PSE State Diagram (#289, #291, #296, #247)

David Stover

Figure 33–15—Type 3 and Type 4 top level PSE state diagram

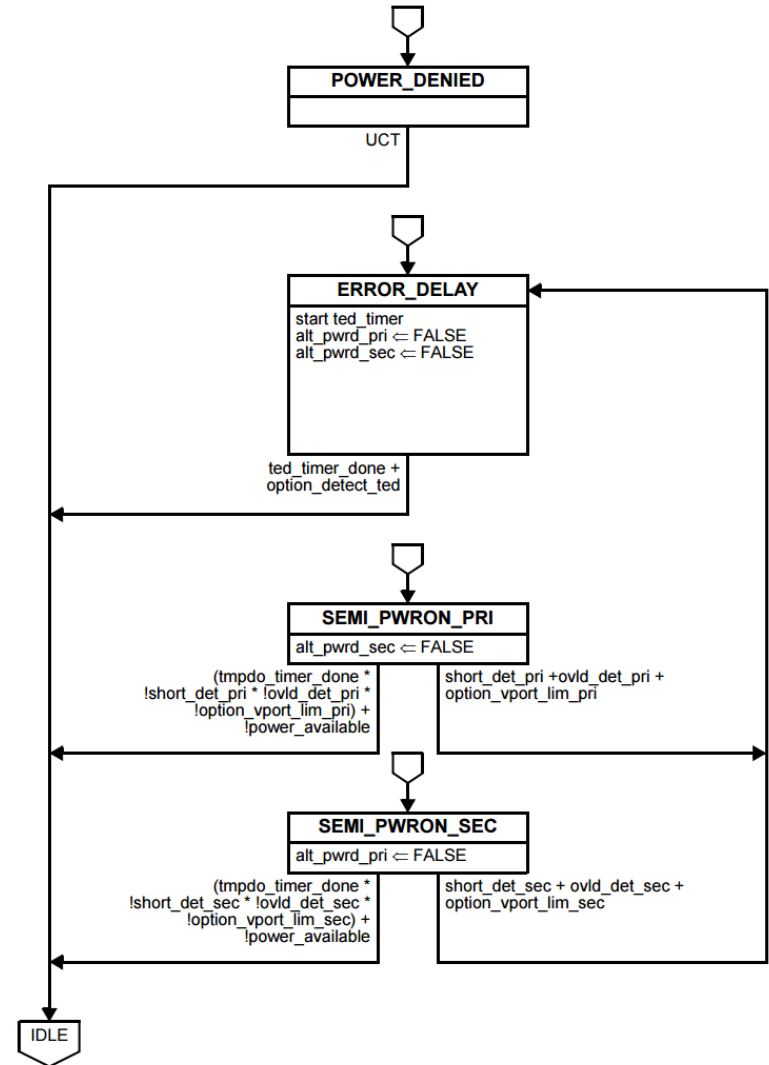
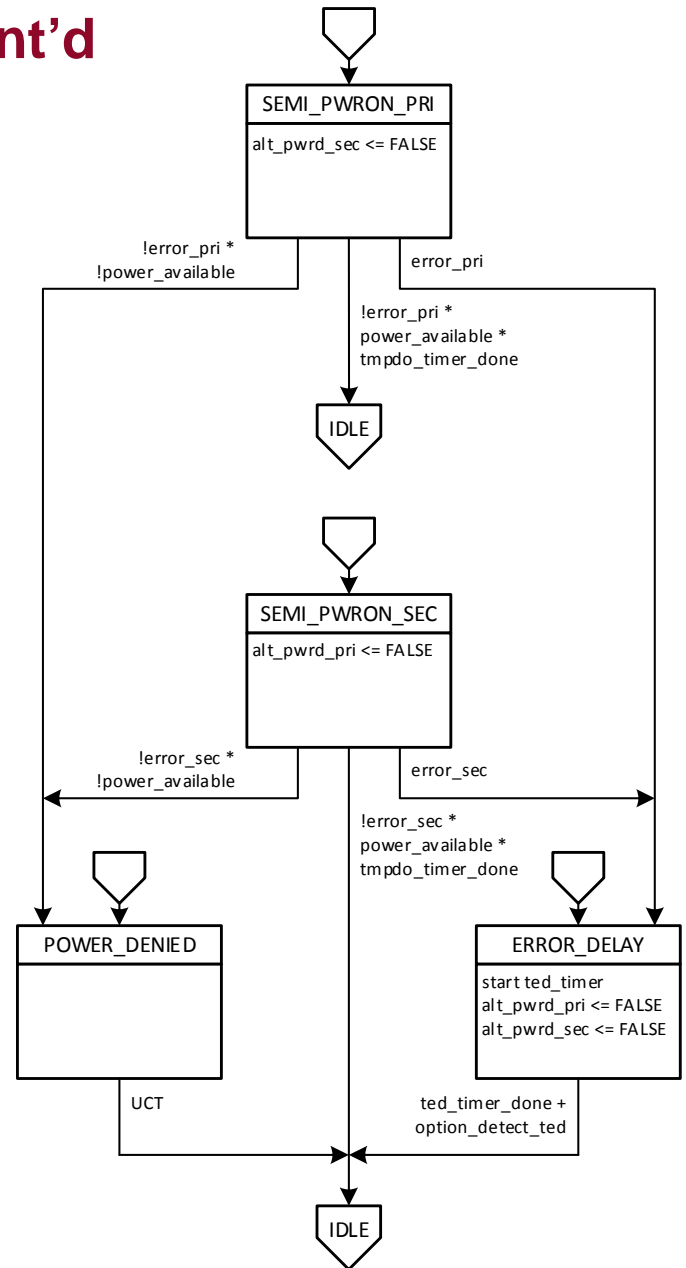
• Problem:

• SEMI_PWRON_* states...

- use “power_available” in a manner inconsistent with POWER_ON state.
- bypass POWER_DENIED

- Replace Figure 33-15 (P96) as follows

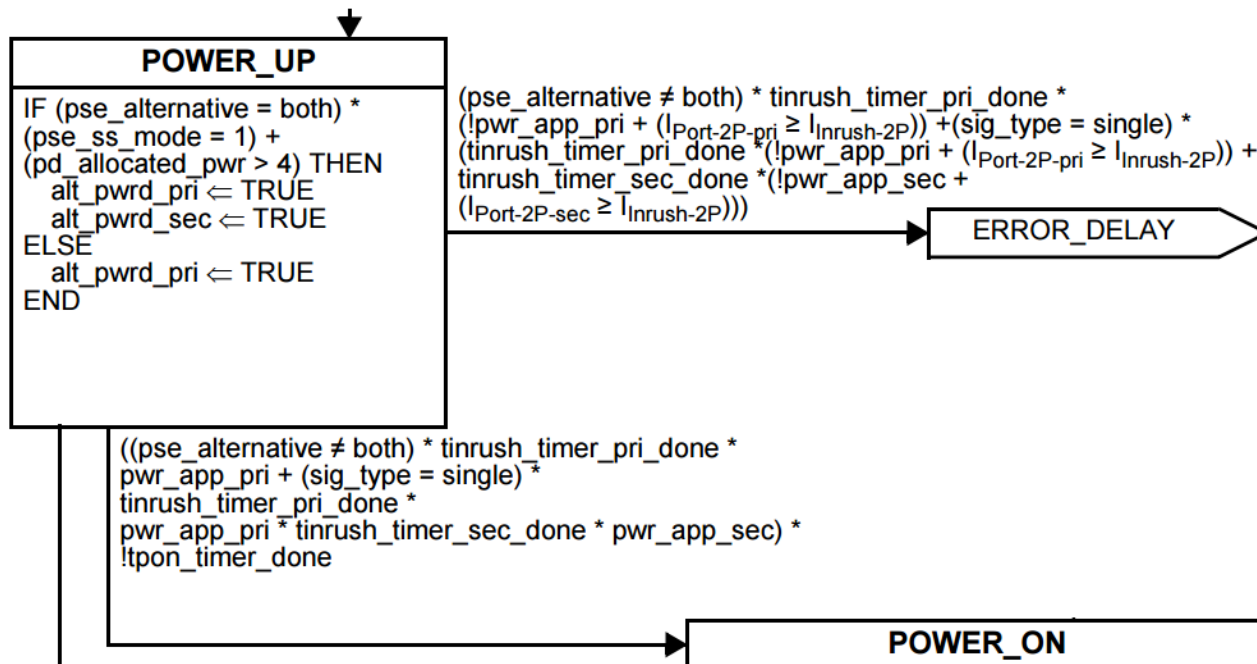
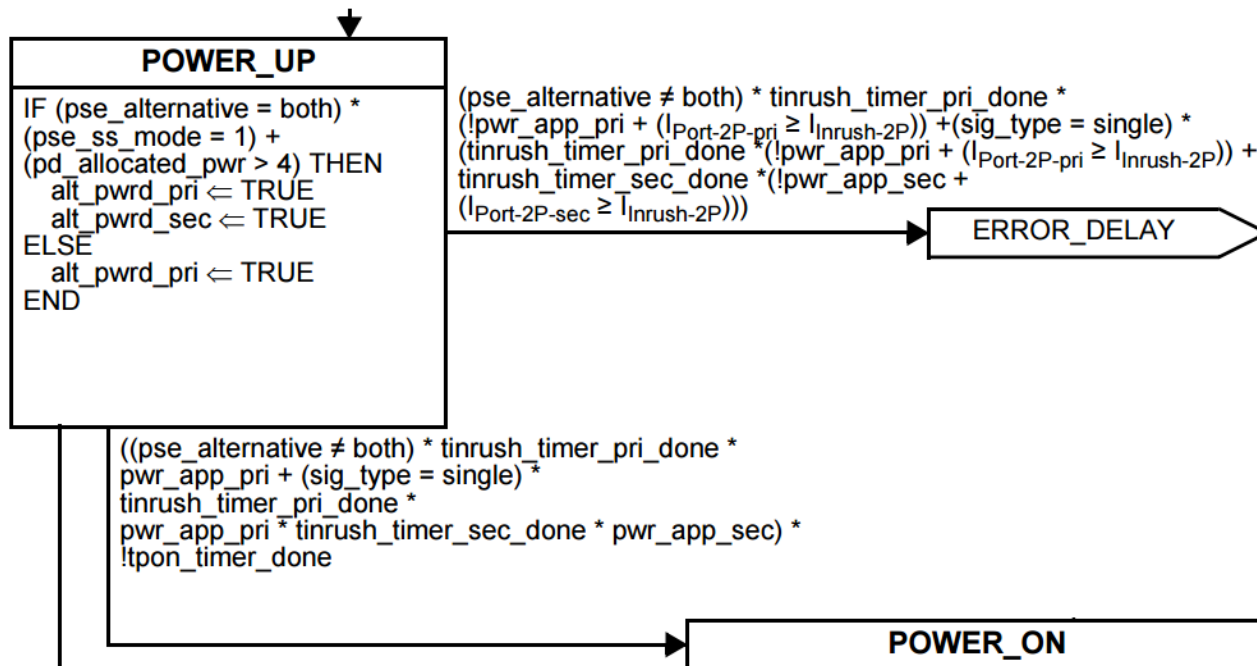
- Definition of pwr_app_*: “A variable indicating that the PSE...is not in a current limiting mode, and is operating beyond the POWER_UP requirements of 33.2.8.6.”
- It is redundant and incomplete to include the term “(I_{Port-2P-pri} >= I_{Inrush-2P})” in transition logic from POWER_UP_* to ERROR_DELAY_* when the PSE is already required to enforce I_{Inrush-2P} and I_{Inrush} per definition of “!pwr_app_*”

- Transition logic out of POWER_UP is difficult to parse; review

–Example: Check for “!tpon_timer_done” is absent from “ERROR_DELAY”, allowing for multi-true into ERROR_DELAY and IDLE.

- Use of “pse_alternative”, “sig_type” to identify powered pairsets is incomplete, superfluous

- Example: does not take into consideration pse_ss_mode, which controls “alt_pwr*_ <= TRUE”

- Instead, let’s leverage PSE Inrush SD:

- “tinrush_timer_*_done <= TRUE” only when the corresponding “alt_pwr*_ <= TRUE”

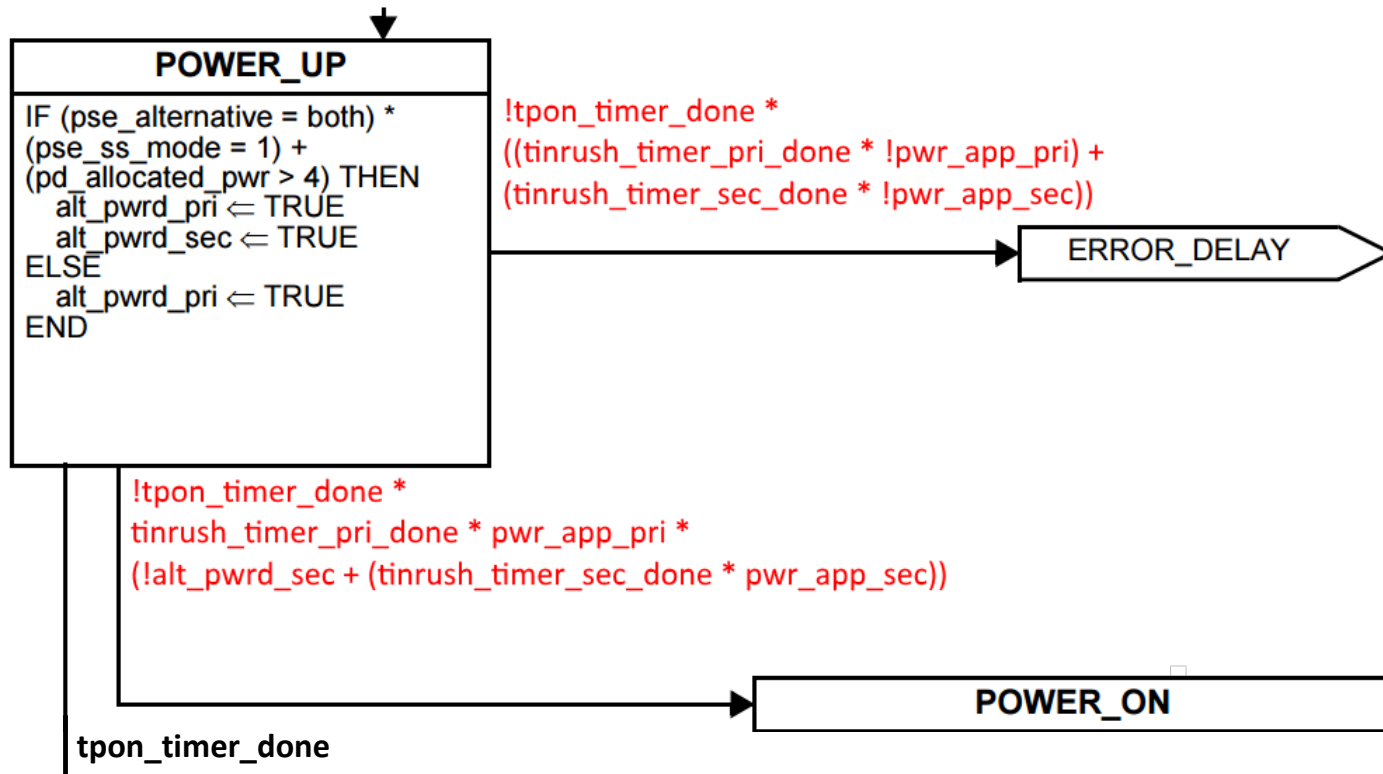
- Remedy (1 of 2):

- Modify Figure 33–15 as follows

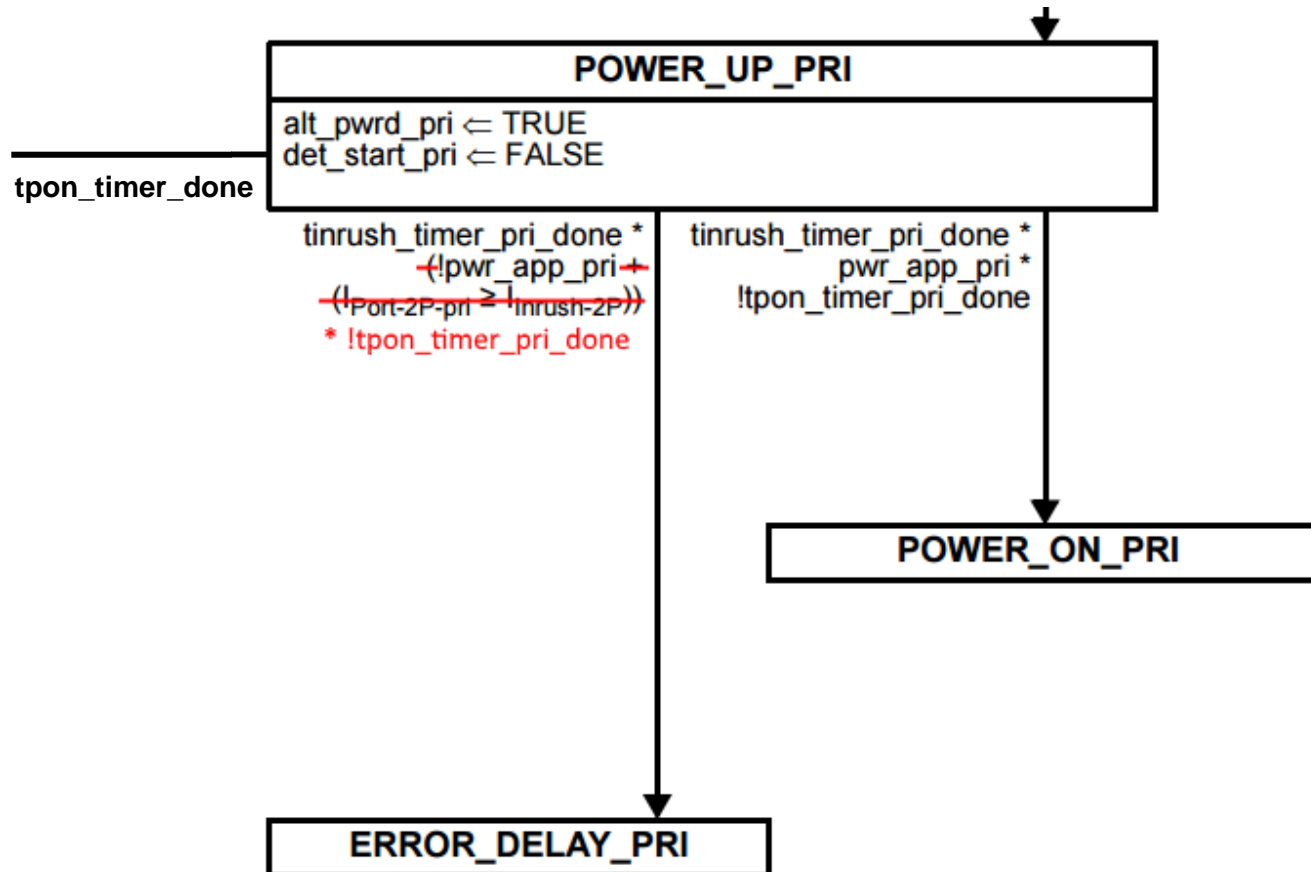
- **Remedy (2 of 2):**

- Modify Figure 33–16 as follows and make similar changes to Figure 33–17
